COVER SHEET
C0.0
1 of 53 Sheets

EAST TOWN CROSSING PHASE 1

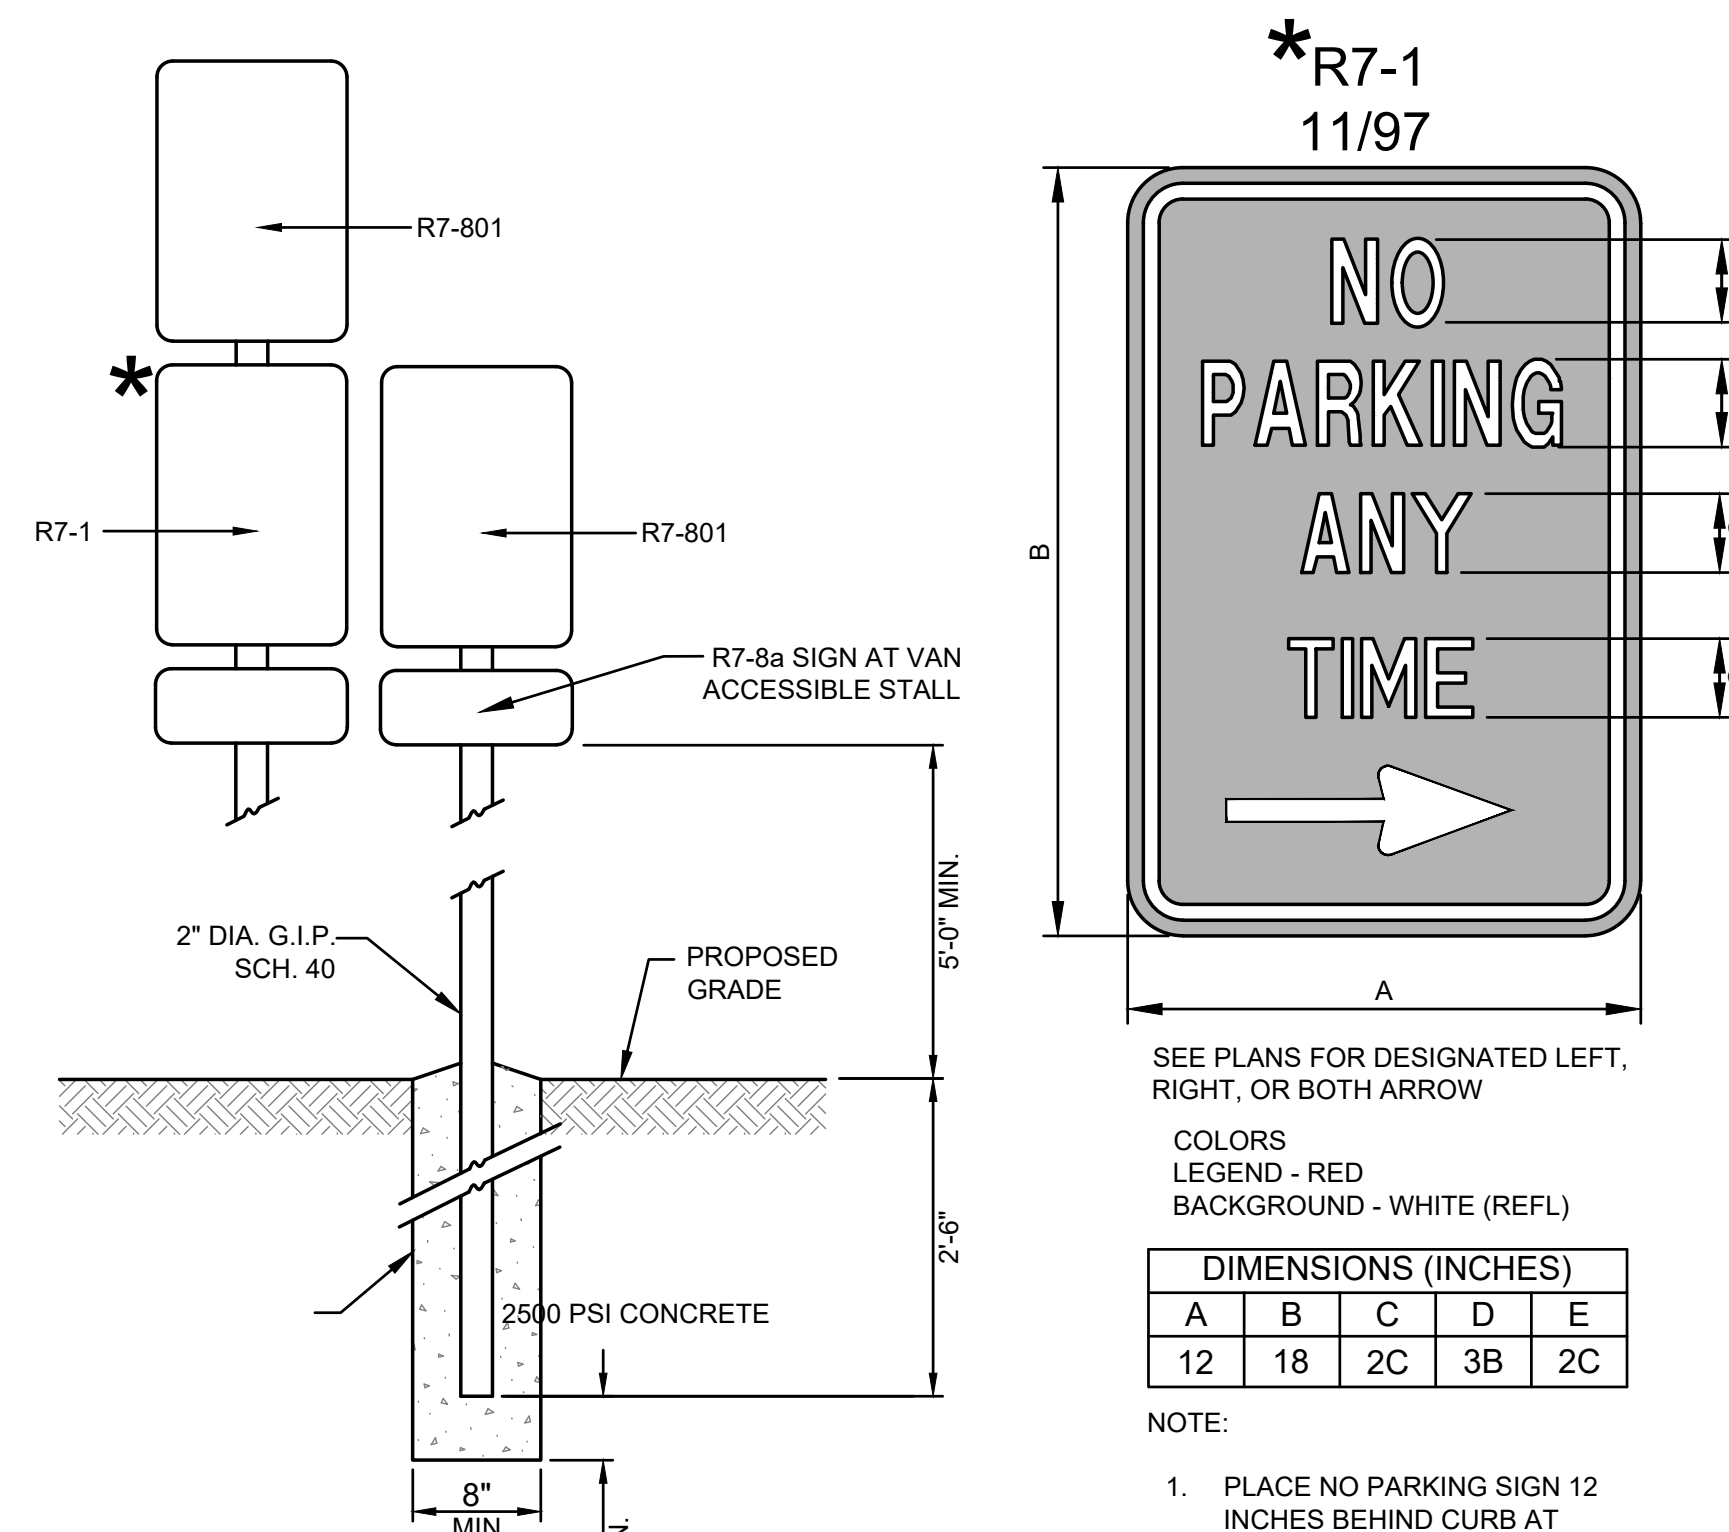
Drive-through window lanes and facilities shall be oriented away from residential zones, and shall be screened from residential zones and public streets to obscure vehicle headlight from shining directly into public streets or residential zones. Required screening shall be a minimum height of three feet above the grade of the drive, and shall be sufficiently dense to obscure at least 80 percent of vehicle headlights prior to occupancy and use, and 100 percent of vehicle headlights within one year of occupancy and use. Acceptable screening materials shall include the use of building walls, berms, landscaping and/or solid fencing. (Ord. 3073 § 18, 2014; Ord. 2866 § 3, 2006; Ord. 2826 § 6, 2005; Ord. 2694 § 5, 2001; Ord. 2615 § 1, 1999; Ord. 2563 § 1, 1998; Ord. 2454 § 1, 1995; Ord. 2393 § 1, 1994; Ord. 2316 § 1, 1992; Ord. 2196 § 4, 1989; Ord. 2147 Exh. A, 1987).

Added berm in front of drive thru area. Due to space limitations, a solid fence is proposed in front of the parking areas. This meets the requirements for Ch 20.30 C Commercial Zones acceptable screening materials of PMC. Landscaping will also be provided

GRADING PLAN NW

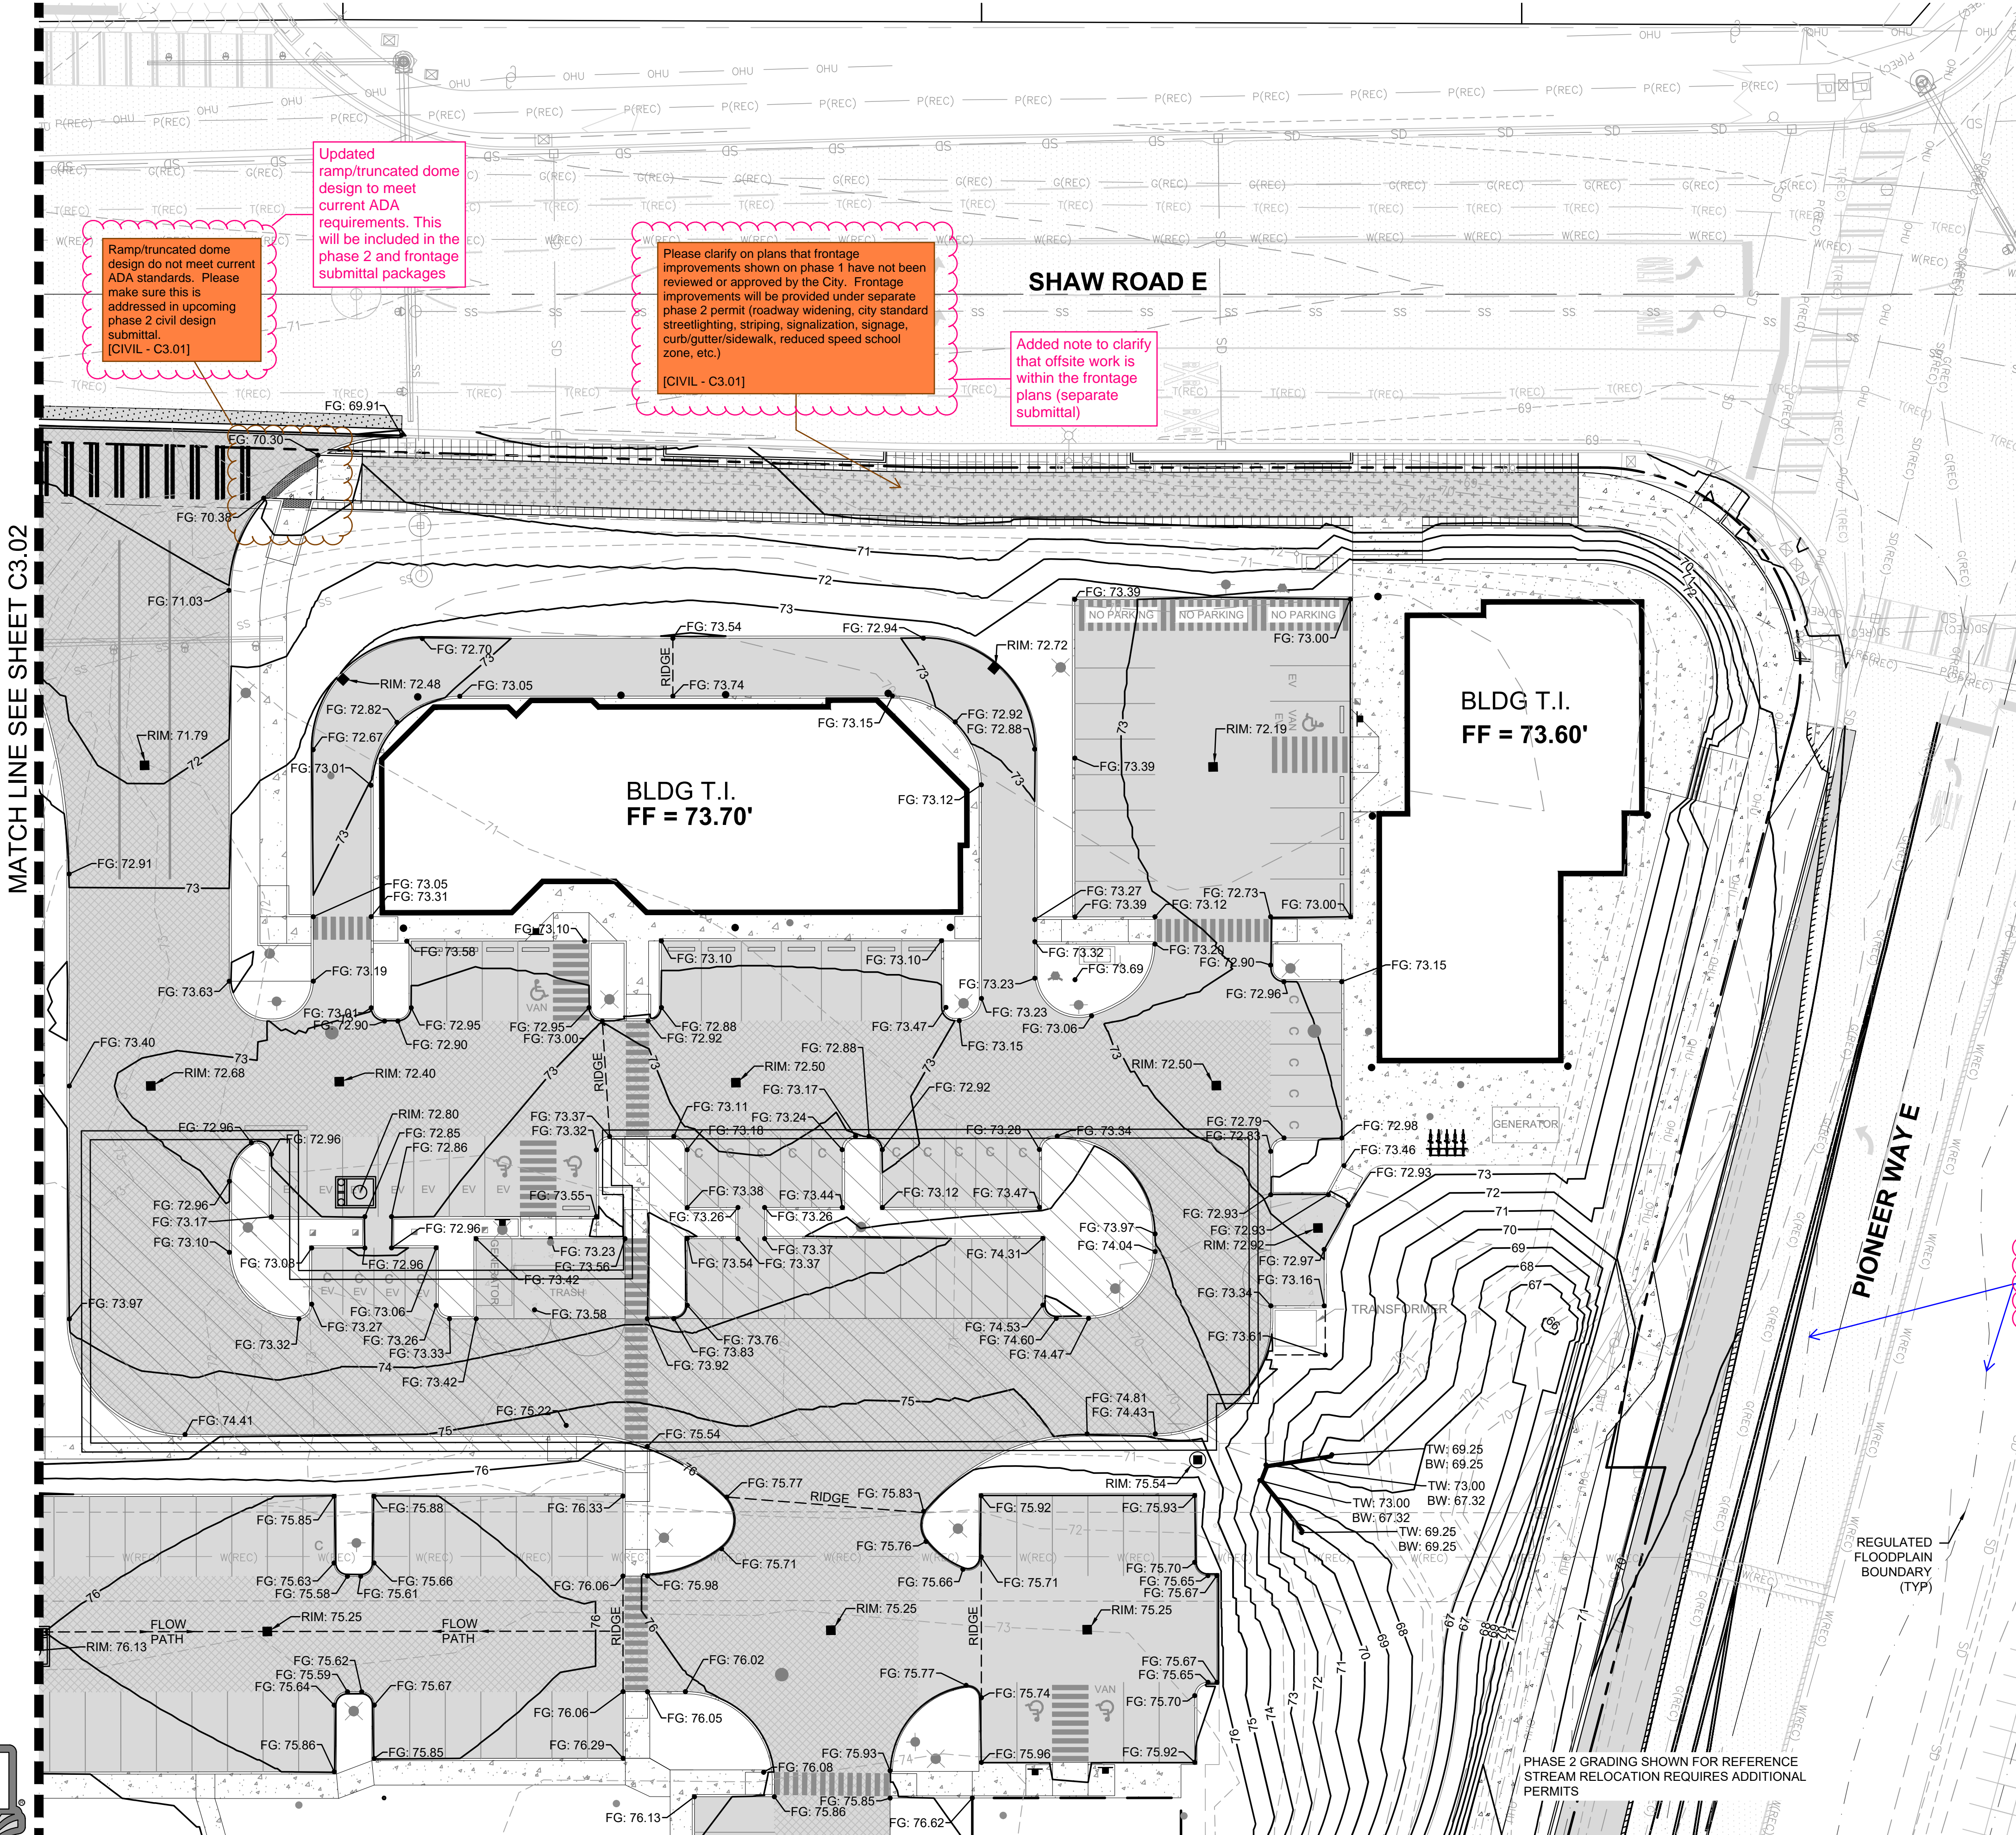
Please emphasize the limits of the regulated floodplain for clarity (per the LOMR, Effective September 8, 2022). [Plans Sht C3.01, Pg 11 of 53]

Sheet Title:
GRADING PLAN SW

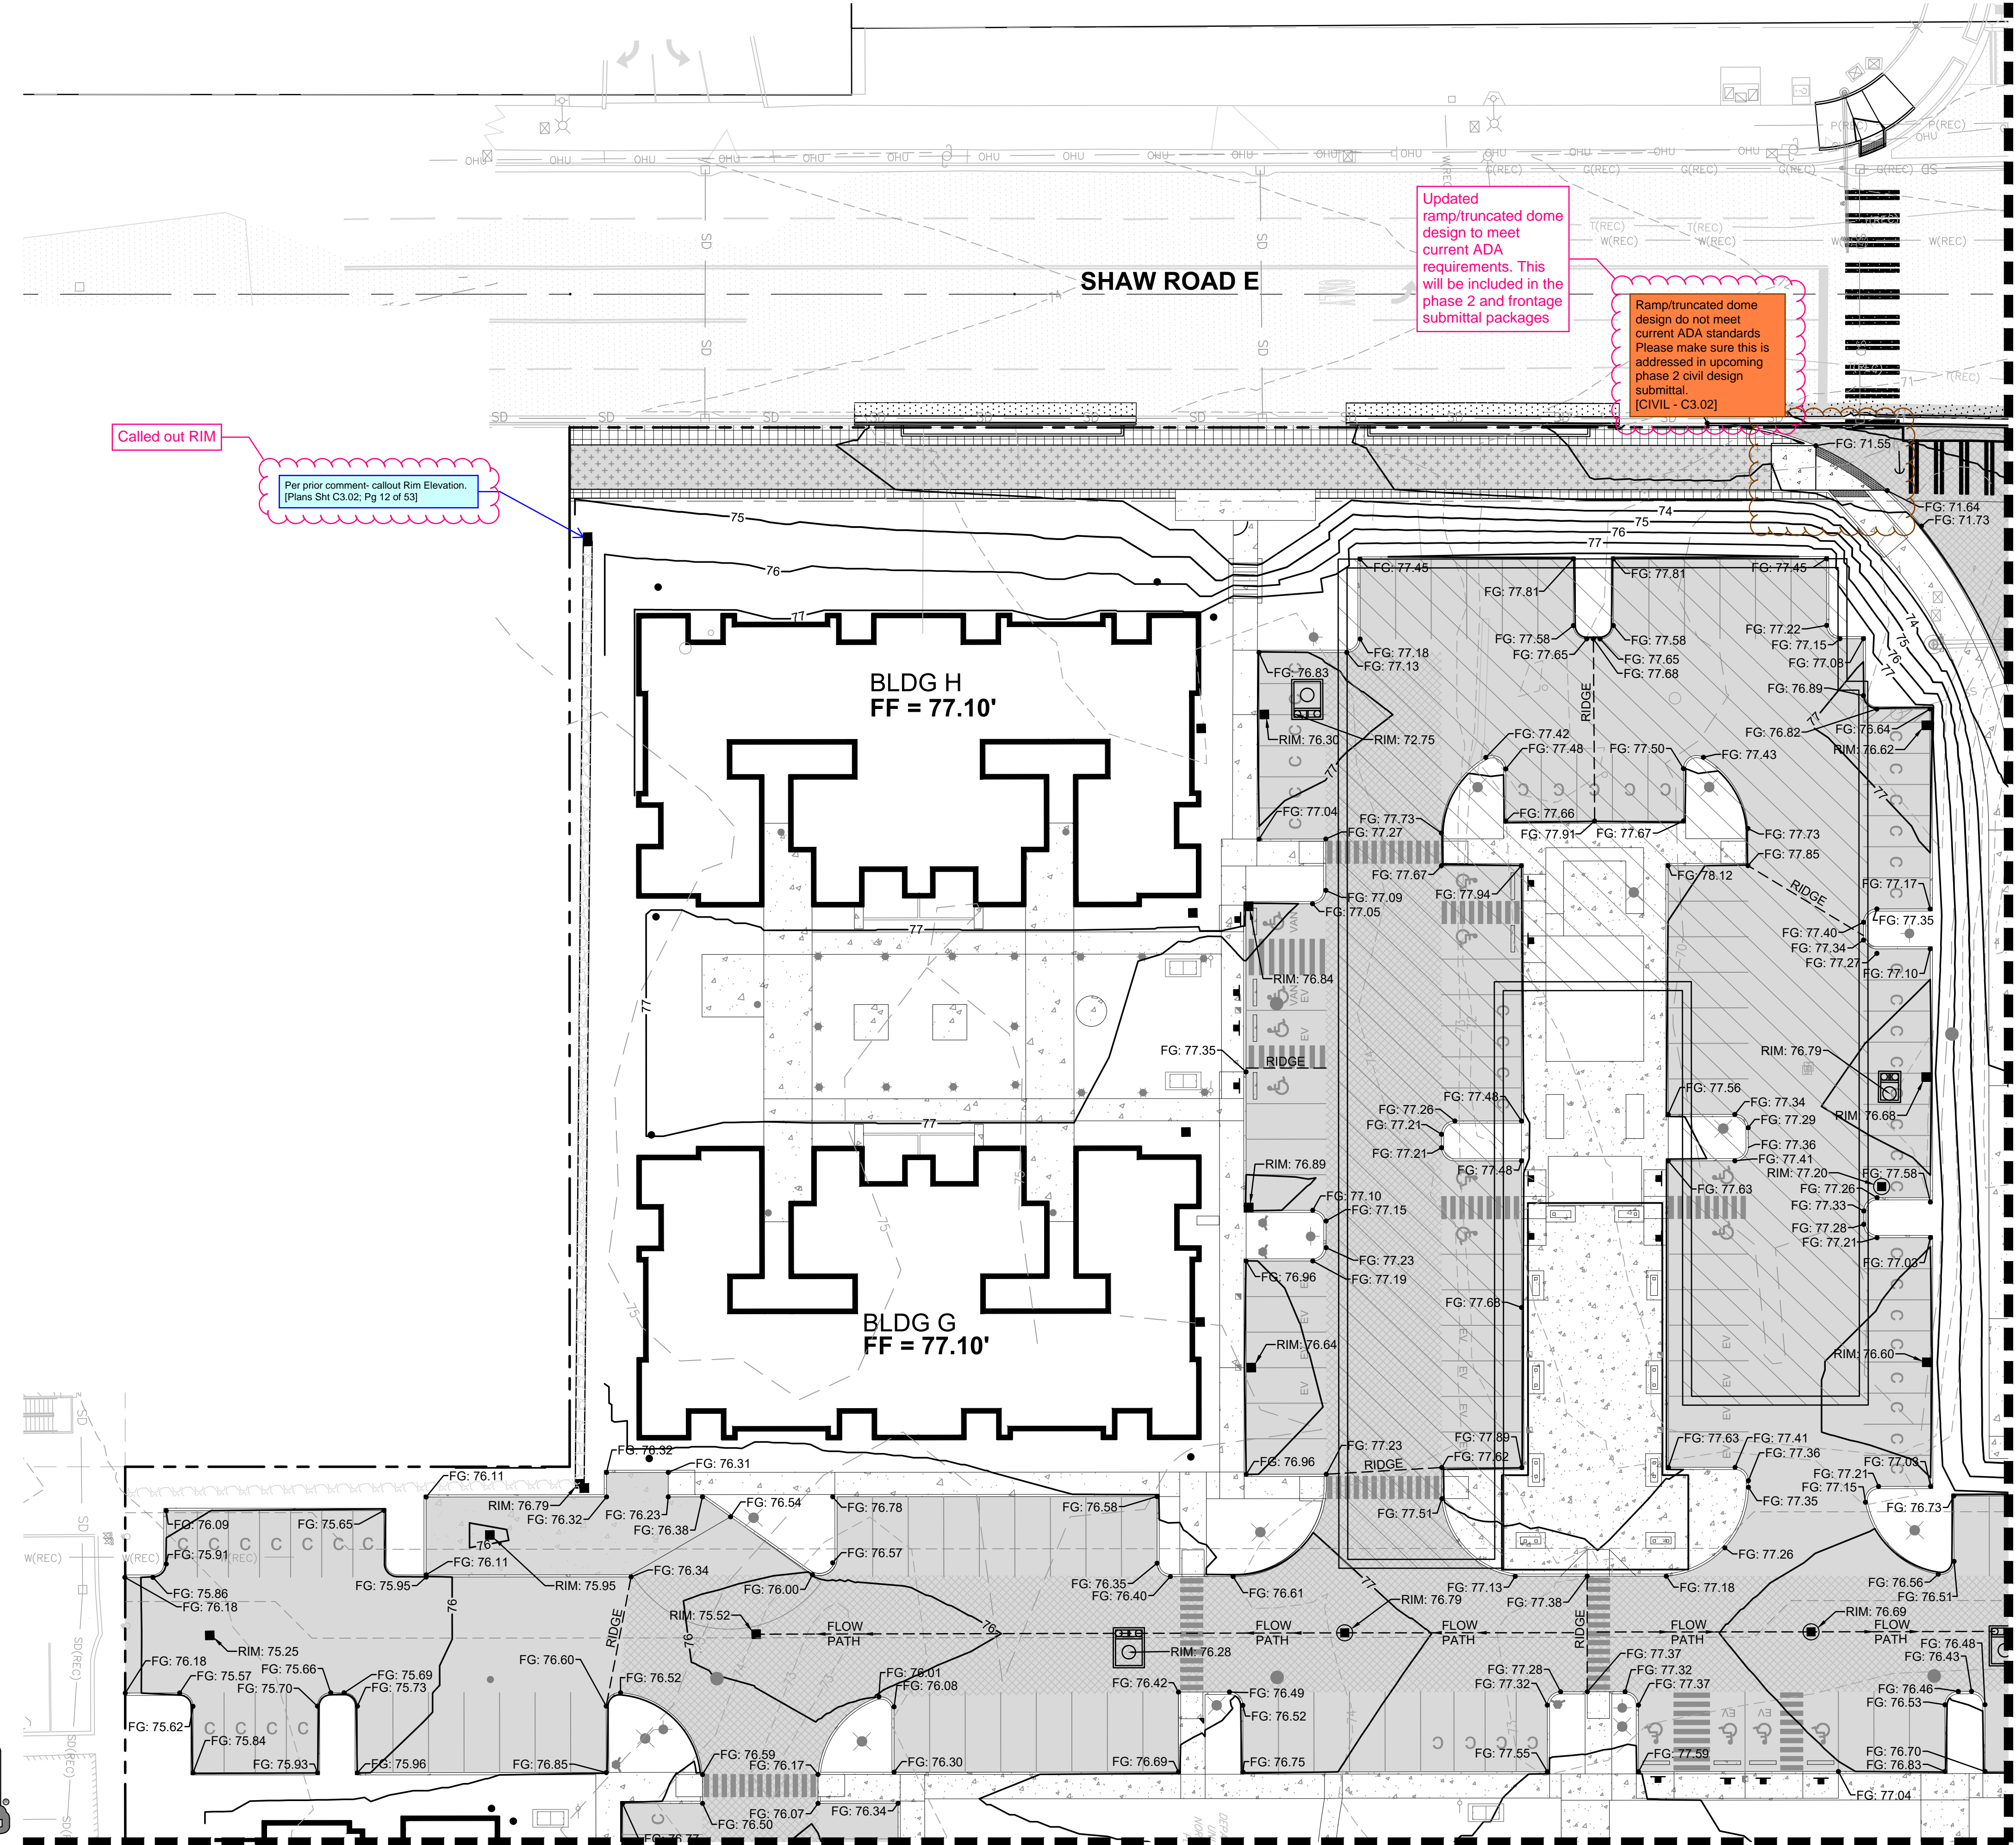
Per prior comment- callout Rim Elevation. (Plans SH C3.02, Pg 12 of 53)
